## SERVICE BULLETIN 23-01

**RE:** Immediate and recurring inspection; torque setting and replacement of damaged cap bolts in aftermarket SPL front lower control arms, FLCA SKU's: FLCA F8X, FLCAR F8X, FLCA E9X, FLCAR E9X, FLCA F3X, FLCAR F3X, FLCA G29, FLCA G8X, FLCA G8X IX, FLCA GT350, FLCA ATS, FLCA CAM6, FLCA S550

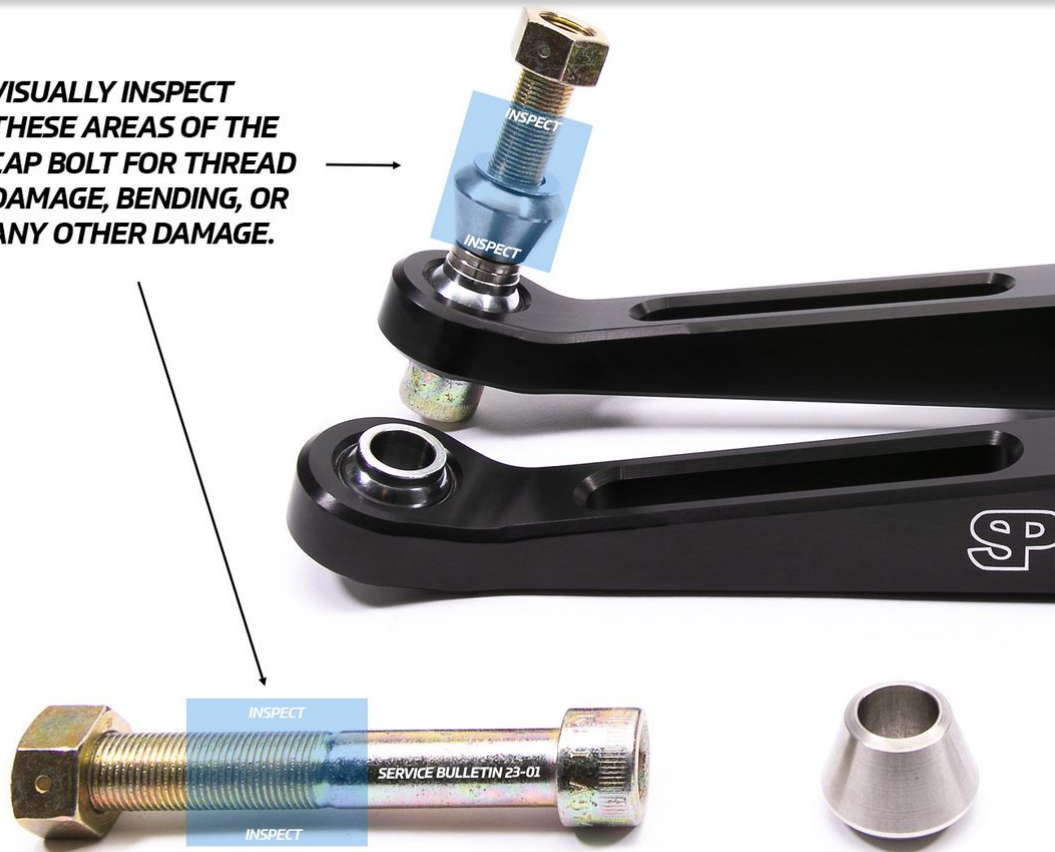
**Description of Issue:** SPL has received inquiries regarding bending and failures of cap bolts used in SPL front lower control arms. Information supplied to SPL indicates inadequate or un-retained torque of retaining nut/bolt to lower control arm may be contributing to bending and fatigue of grade-8 fasteners.

**Recommended Action:** Visually inspect cap bolt and control arm attachment points for bending, impact or other wear/distortion/damage; paying particular attention to the area where cap bolt threads exit retaining nut:

**VISUALLY INSPECT THESE AREAS OF THE CAP BOLT FOR THREAD DAMAGE, BENDING, OR ANY OTHER DAMAGE.**

**Immediately Remove and Replace any cap bolt with signs of bending distortion or damage! Do NOT drive the vehicle until it is properly repaired. (contact SPL for part number)**

1. Clean threads and re-torque undamaged cap bolt retaining nuts to 180 ft-lbs (dry threads). SPL strongly recommends replacement of any cap bolts where inspection indicates installed torque less than 110 ft-lbs, regardless of damage or time in use.

To check current installed torque, set a calibrated click-type torque wrench to 110 ft-lbs and attempt to tighten the nut. There should be no rotation (additional tightening) of the nut before it clicks. For beam-type torque wrenches, simply apply torque until it measures 110 ft-lbs, again, there should be no additional tightening/rotation felt.

# ***PREVIOUS CAP BOLT***

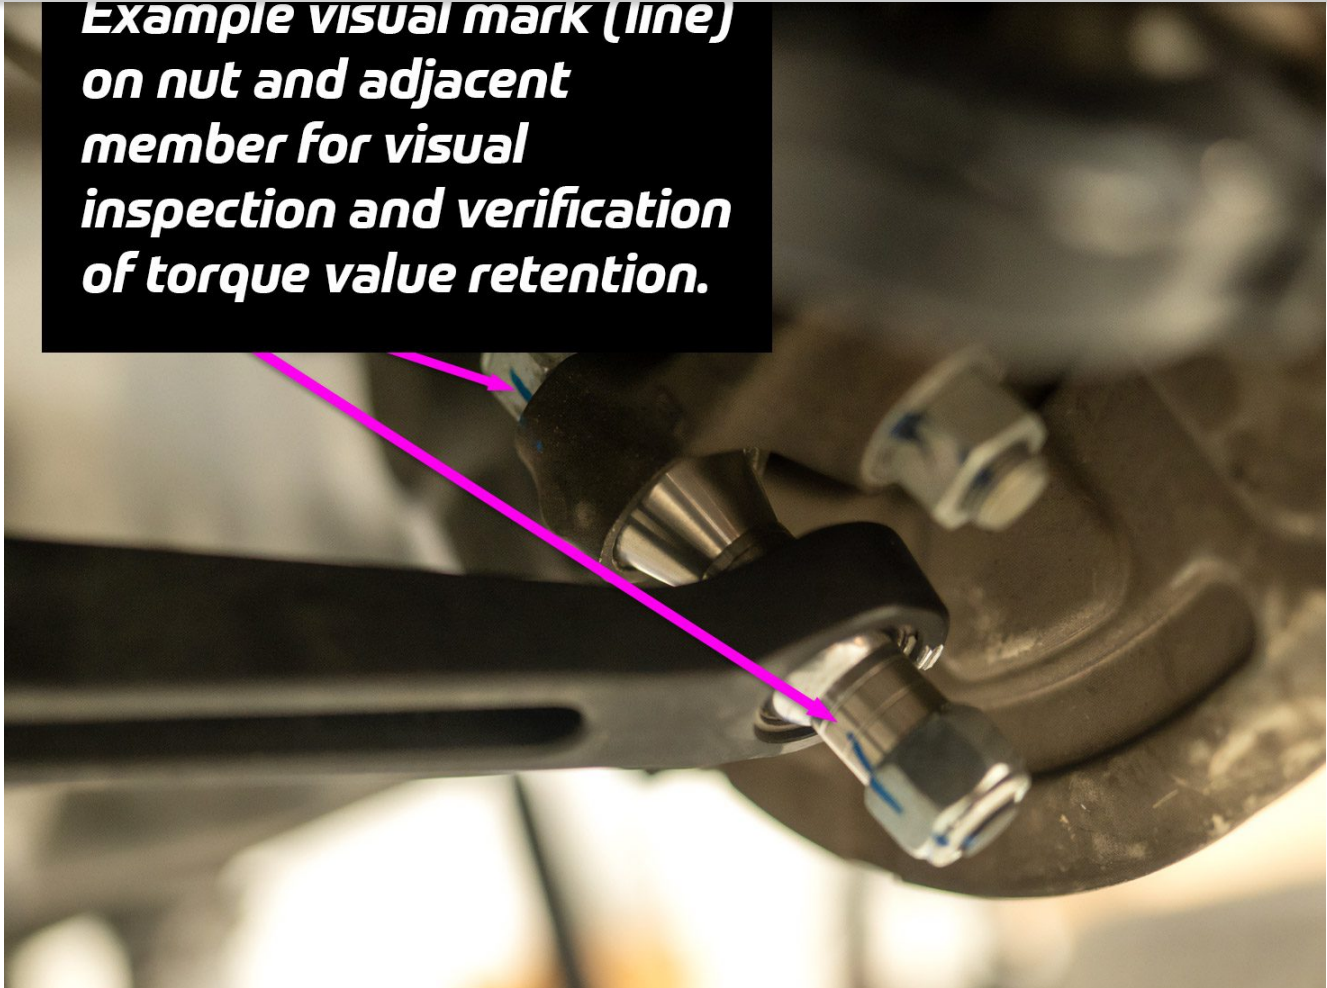
Current SPL kits ship with a stud & nut fastener that will retrofit to older kits as replacement parts (See illustrations below).

***PREVIOUS  
CAP BOLT***

***REPLACEMENT  
STUD***
